## ADDENDUM #2

November 8, 2023

Project: Bethel Park Restoration

Earthwork heat map for cut/fill

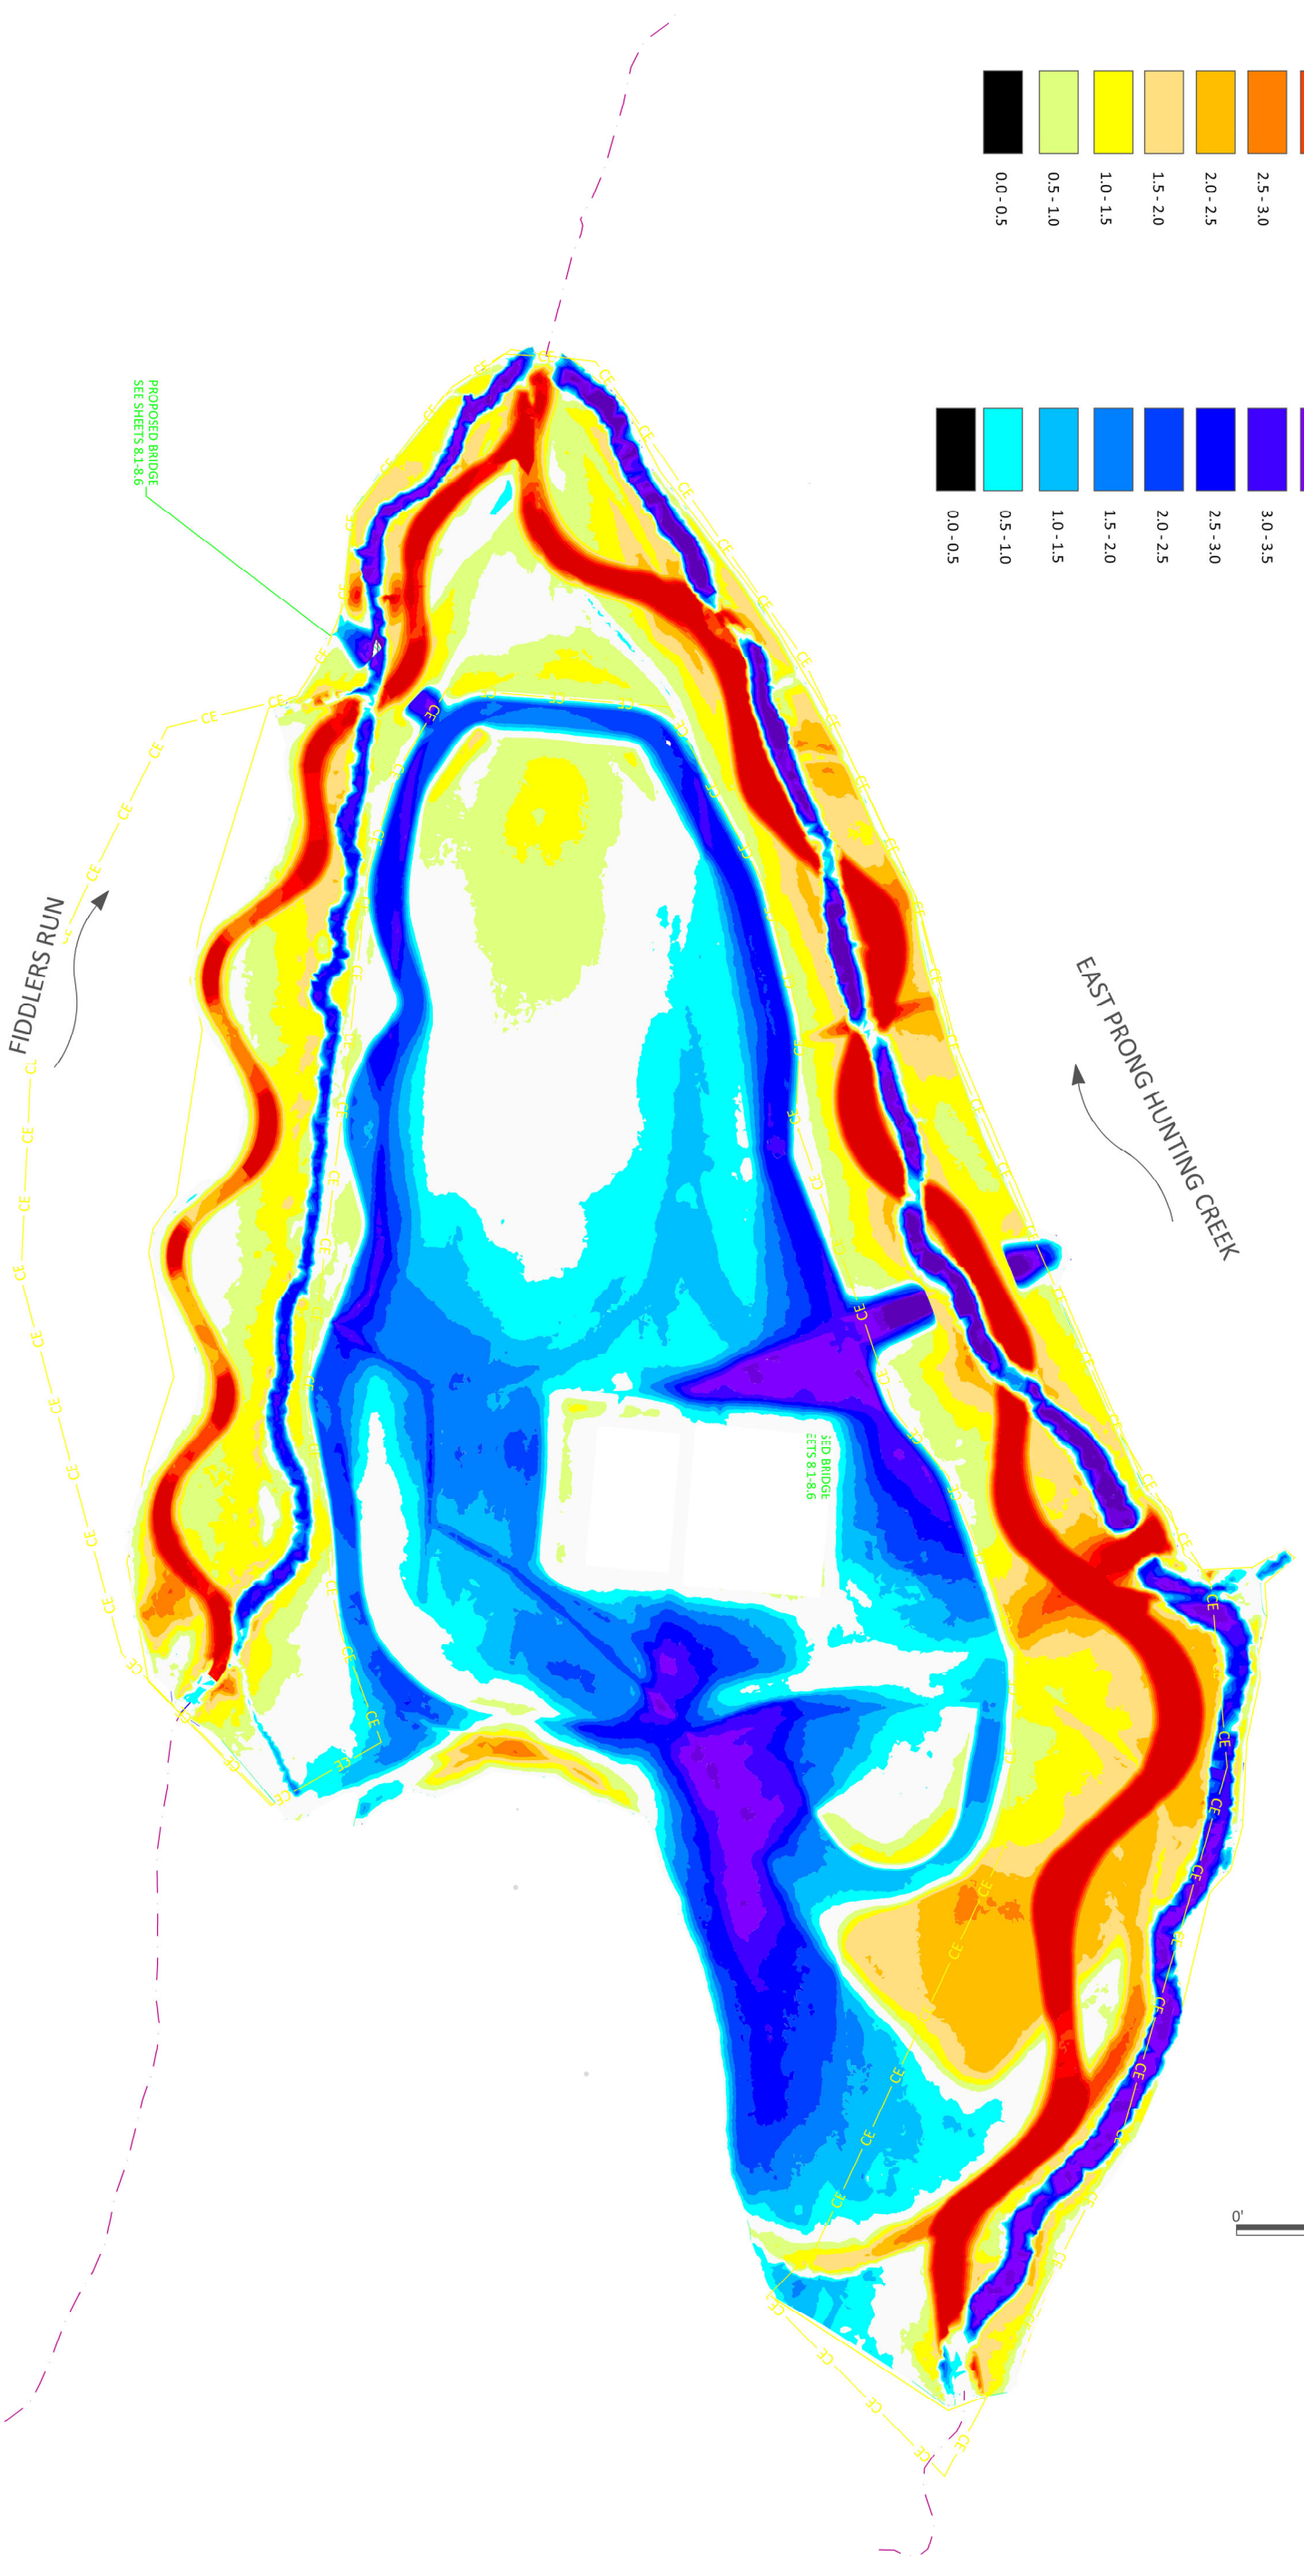
1. Comment: In efforts to calculate earthwork cut/fill for the lump sum grading line item, please forward the CAD file.

**Response:** Earthwork quantities were provided as part of Addendum 1. A heat map for cut/fill areas and depths is provided as part of this addendum. A model-space composite CAD file is being provided for the purpose of determining quantities.
